CABINET MEMBER FOR ENVIRONMENT – 17 MARCH 2016

PROPOSED CONTROLLED PEDESTRIAN CROSSING – A4260 OXFORD ROAD, BODICOTE

Report by Deputy Director of Environment & Economy (Commercial)

CABINET MEMBER FOR ENVIRONMENT 21 MAY 2015		
A4260 OXFORD ROAD/BROAD GAP BODICOTE PROPOSED PEDESTRIAN CROSSING		
Drawing Status		
Drawn by: CJM	Checked by:	Approved by:
Date drawn: 08/05/2015	Date checked:	Date approved:

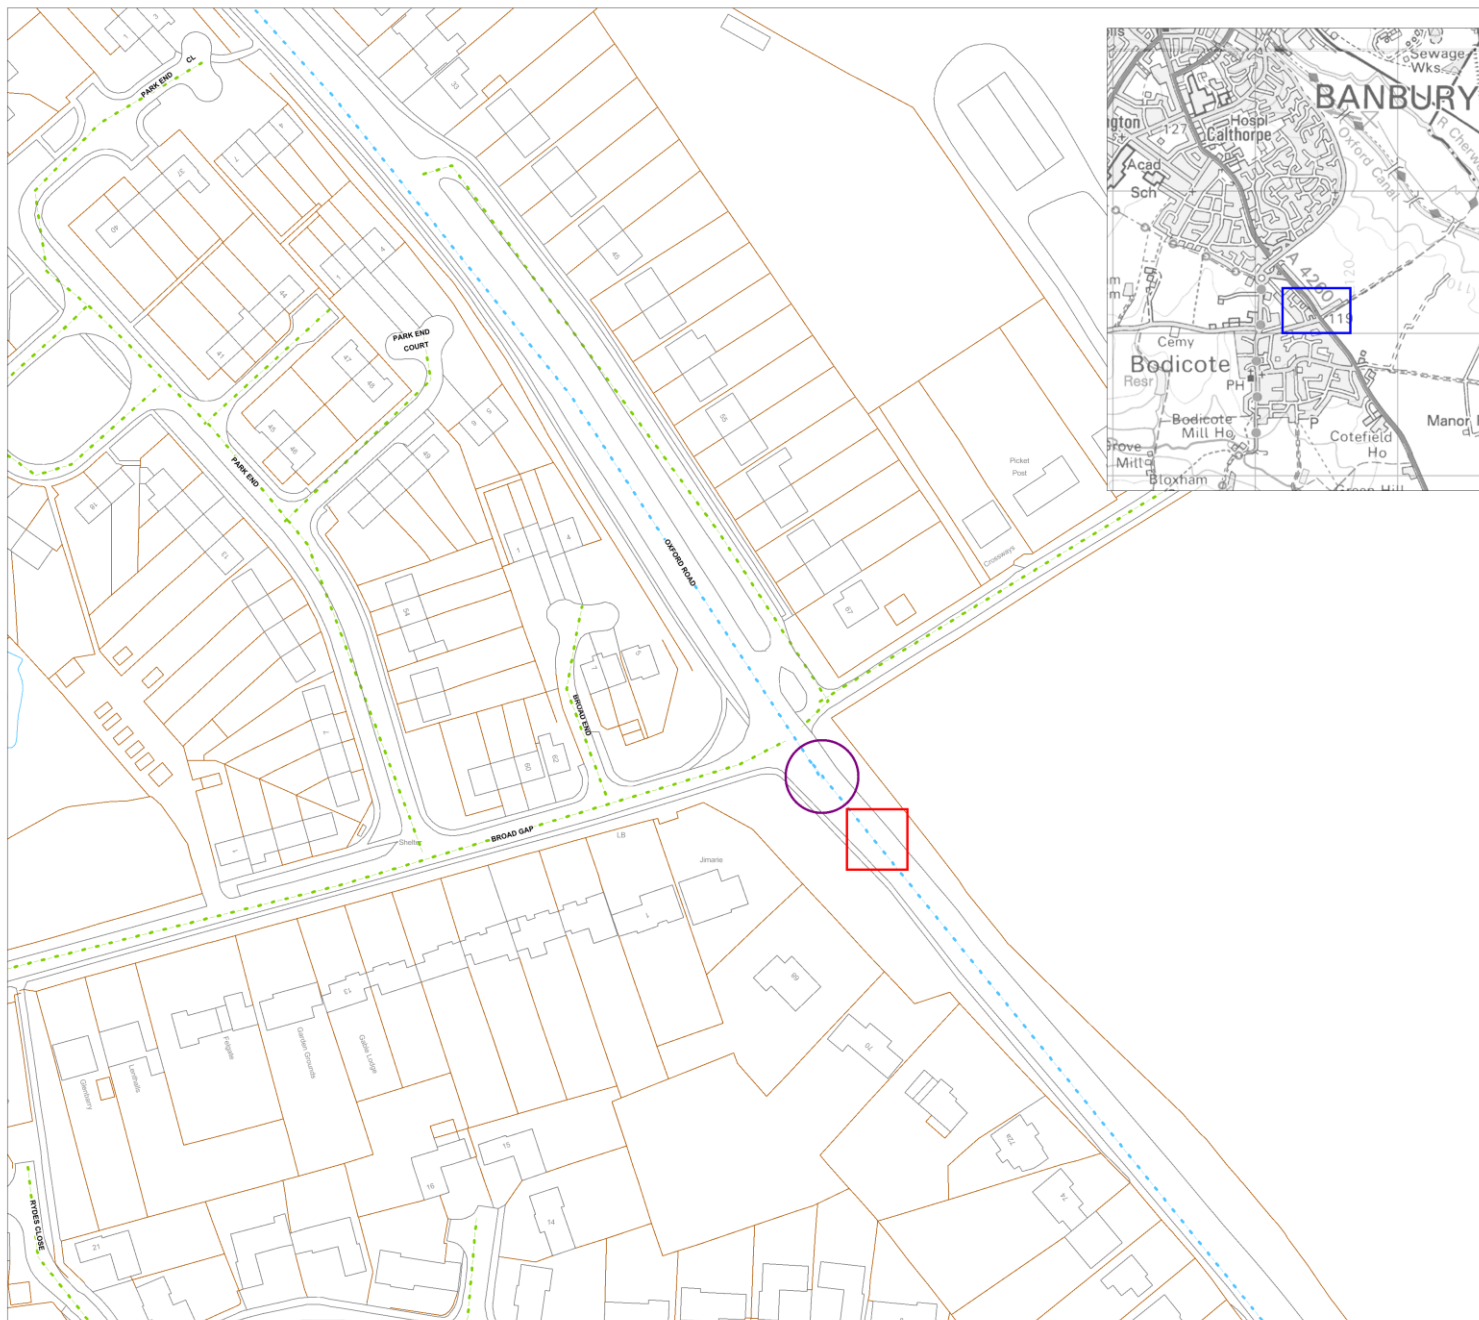
ID	RESPONDENT	SUMMARISED COMMENTS
1	Parish Council (Bodicote)	<p>Objects - due to the following reasons:</p> <ul style="list-style-type: none"> ▪ Crossing should be sited just north of Broad Gap, enabling traffic turning left to see stationary traffic at crossing and would allow vehicles to turn right without restriction, ▪ It would also save a considerable amount of money and disruption, ▪ The left turn lane allows traffic to flow freely to Banbury, ▪ If the bus lane is removed, buses will hold up traffic when stopping, ▪ This puffin crossing was agreed 10 years ago, we do not believe we have had the correct consultation, and the traffic situation is very different now from 10 years ago. <p>In summary we feel a proper review of the traffic situation should be undertaken and that this proposal from 10 years ago should not simply be given the go-ahead. Whilst it may conform to certain guidance from a traffic engineering point of view, we believe it does not chime with the actual situation on the ground.</p>

2	Thames Valley Police (Traffic Officer)	<p>No objection – but has the following comments:</p> <ul style="list-style-type: none"> ▪ Distance to the junction at Broad Gap may offer some hazard potential for those on the crossing and traffic emerging from Broad Gap turning right. ▪ Site lines are good with no obvious infrastructure that could compromise safety.

3	Member of public (via email)	<p>Objects - due to the following reasons:</p> <ul style="list-style-type: none">▪ The junction is very busy and is more and more used as a cut through, It can take 5mins to turn right out of Broad Gap to travel south on Oxford Road,▪ The crossing is too close to the junction and will be a distraction when trying to exit safely,▪ There is already a non-control crossing just to the North of the Broad Gap/Oxford Road junction, as this would allow cars turning right out of Broad Gap to do so safely,▪ The crossing will go across a layby/commonly used slip Road and the bus stop. <p>In summary I still object to the proposals on the grounds of safety and being unsafe to pull out the current junction.</p>
---	---------------------------------	---

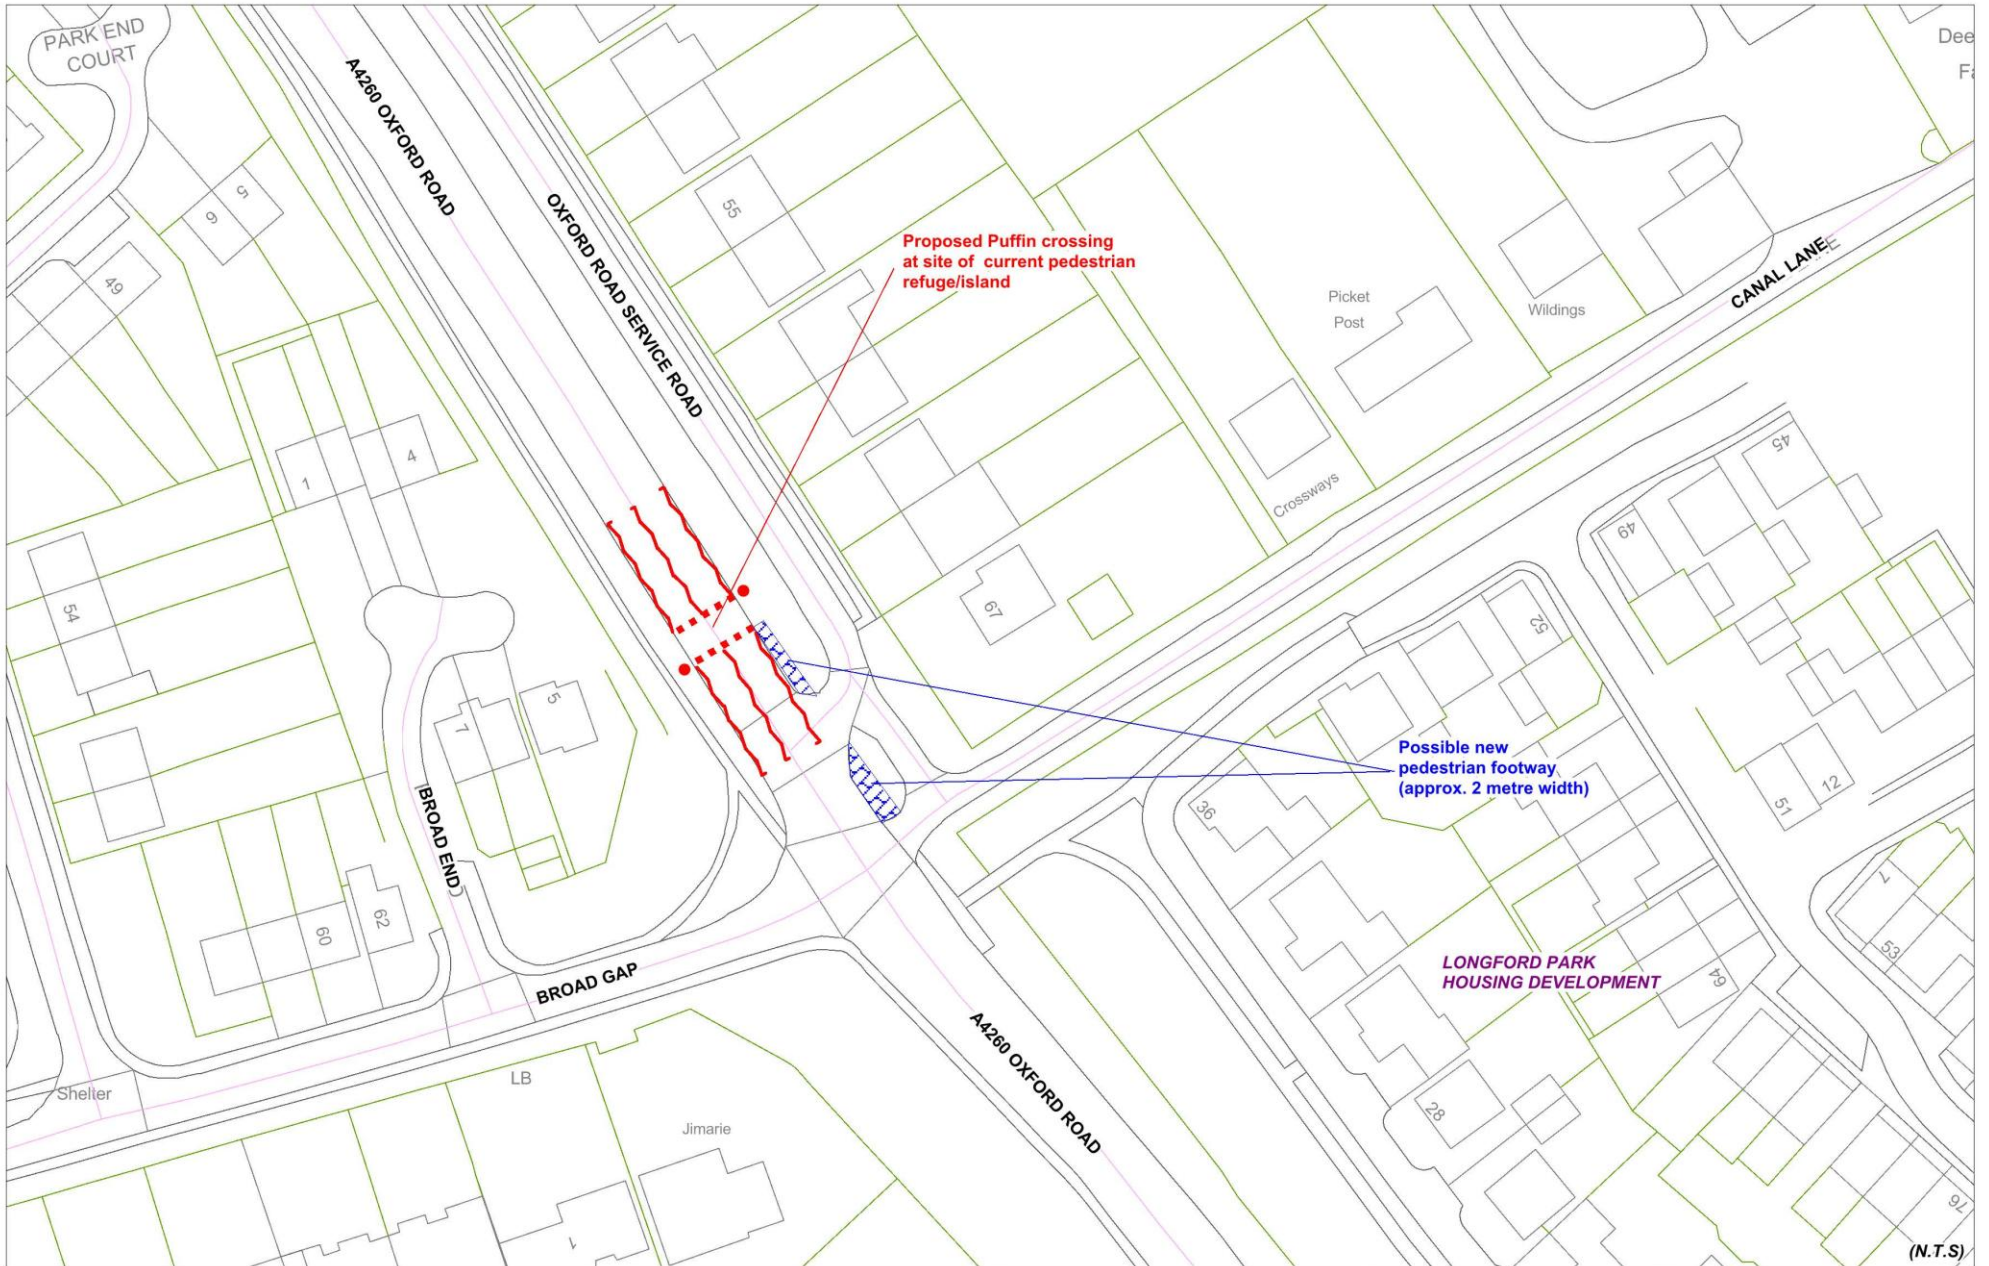
6. The objection was from a resident of Longford Park who was concerned that the revised proposal was too far from the pedestrian access from the development, which would deter residents walking to the school and other village amenities. The new location might also lead to pedestrians attempting to cross the very busy road, leading to a serious risk of accidents and a crossing closer to the pedestrian access was considered a much safer option.

7. Bodicote Parish Council expressed a strong preference for the revised proposal but raised a query as to whether a signalled crossing was needed at all, given that the refuge provided a safe place to cross.

RESPONDENT	SUMMARISED COMMENTS
Fire & Rescue Service	No objection
Thames Valley Police	No objection
Bodicote Parish Council	Support the proposal. The Parish Council far prefers the new location to the original, which had a lot of drawbacks and involved altering the road layout. Queries whether the existing central refuge be used just without any additional work?
Resident, (Linnet Road)	Objects given the distance from the Longford Park walkway. Children and adults traveling to the village are unlikely to walk to the new crossing. Oxford Road is very busy and vehicles travel fast making doing this very dangerous. A crossing closer to the exit would be a much safer option.
Resident, (Longford Park Road)	No objection but would like to see lights at the Broad Gap junction similar to Longford Park/Weeping Cross. In addition, the proposal doesn't take into account traffic build up across Broad Gap, which will prevent cars from getting out. Those turning right towards Oxford would have to wait for the Banbury bound queue to clear from the crossing, only then have to counter the Oxford bound queue build up caused by the crossing.

Email Response, (unknown)	Support. The new location is much better than the previous option. However, the footway would have to be improved as currently it is only grass verge. Would also like to see a box junction to prevent queuing traffic blocking the exit from Broad Gap onto the Oxford Road.
------------------------------	--

12. The objection that the revised proposal would not serve the crossing movements of residents of Longford Park and the majority of other pedestrians crossing at the existing refuge as well as the original proposal does seem to be borne out by the above surveys. This conclusion takes into account the absence of a continuous footway on the north side of Broad Gap, which requires pedestrians to cross Broad Gap (a reasonably busy road) to access the existing refuge, the need for which would be avoided for most users if the crossing is sited to the south of the junction.

14. The support of Bodicote Parish Council reflects their view that their concerns expressed over the initial proposal were largely addressed by proposing the crossing to the north of the junction, although the Council also queried whether any signalled crossing was justified. In responding to the original proposal the Parish Council's concerns related to the impact on traffic movements, rather than the safety and amenity of pedestrians. It is not considered that either of the proposed crossing locations would materially impact on the existing traffic movements in either a positive or detrimental way, following a careful assessment of the operation of the junction and existing bus stop, in addition to the observation of pedestrian crossing movements.

15. The query for the need for a signalled crossing is noted but site observations showed that existing traffic flows are high throughout the working day and are likely to increase in the future. The existing refuge is quite narrow and does not provide a comfortable area for several pedestrians to cross or for those with child buggies, as was observed in the site survey.

16. The concern expressed by a resident on the potential for increased queuing, and the request for the provision of a signalled junction with pedestrian phase is noted but there is no funding available for such a project. Similarly the request from a resident for a box junction is noted; the need for markings could be included as a low cost addition to either option if progressed.
